Work Order ID 141926

Item Name: Quick Release Basket and Long Cargo Tube Mounting Provisions, Fits LH or RH

TO AMEND INSTALLATION INSTRUCTIONS D350-607-3 Rev.D,
INSTALLATION INSTRUCTIONS D350-607-4 Rev. C AND
INSTRUCTIONS FOR CONTINUED AIRWORTHINESS ICA-D350-607 REV. 6

A	NEW ISSUE	AJS	14.05.16
REV.	DESCRIPTION	BY	DATE
DESIGN	AJS	DART AEROSPACE LTD HAWKESBURY, ONTARIO, CANADA	
DRAWN	AJS		
CHECKED		DRAWING NO.	REV. A
MFG. APPR.	N/A	DSI 9699	SHEET 1 OF 2
APPROVED		TITLE	SCALE
DE APPR.		LUG REPLACEMENT	NTS
DATE	14.05.16	COPYRIGHT © 2014 BY DART AEROSPACE LTD THIS DOCUMENT IS PRIVATE AND CONFIDENTIAL AND IS SUPPLIED ON THE EXPRESS CONDITION THAT IT IS NOT TO BE USED FOR ANY PURPOSE OR COPIED OR COMMUNICATED TO ANY OTHER PERSON WITHOUT WRITTEN PERMISSION FROM DART AEROSPACE LTD.

FIGURE 1: INSTALLATION OF D4775-041 FWD STRUT

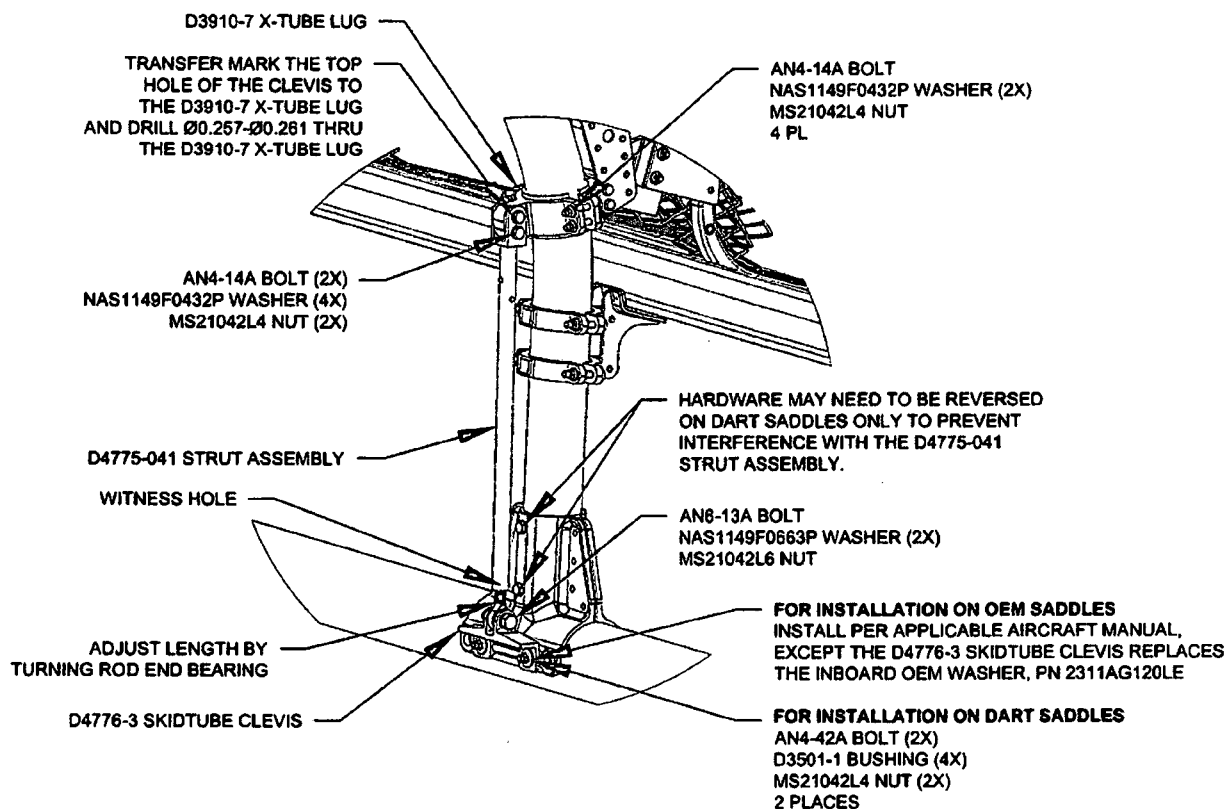
- 3.1 Substitute the Forward Lower D3910-5 X-Tube Lug with the D3910-7 X-Tube Lug as shown in Figure 1.
- 3.2 Install the forward D4775-041 Strut Assembly. Transfer mark from the upper hole on the clevis of the D4775-041 Strut Assembly to the D3910-7 X-tube Lug and drill thru the lug $\varnothing 0.257$ - $\varnothing 0.261$ as shown in Figure 1. Touch up chemical conversion coating per MIL-DTL-5541. Check the witness holes located at the bottom end of the D4775-041 Strut Assemblies to ensure that the thread from the rod end extends past the witness hole.
Torque MS21042L4/-4 nuts to 50-70 in-lbs (5.7-7.9 N-m). Torque MS21042L6/-6 nuts to 160-190 in-lbs (18.1-21.5 N-m).
- 3.3 Complete the installation in accordance with Installation Instructions D350-607-3 Rev. D or D350-607-4 Rev. C.

Modify the quantities for D3910-5 and add D3910-7 as follows:
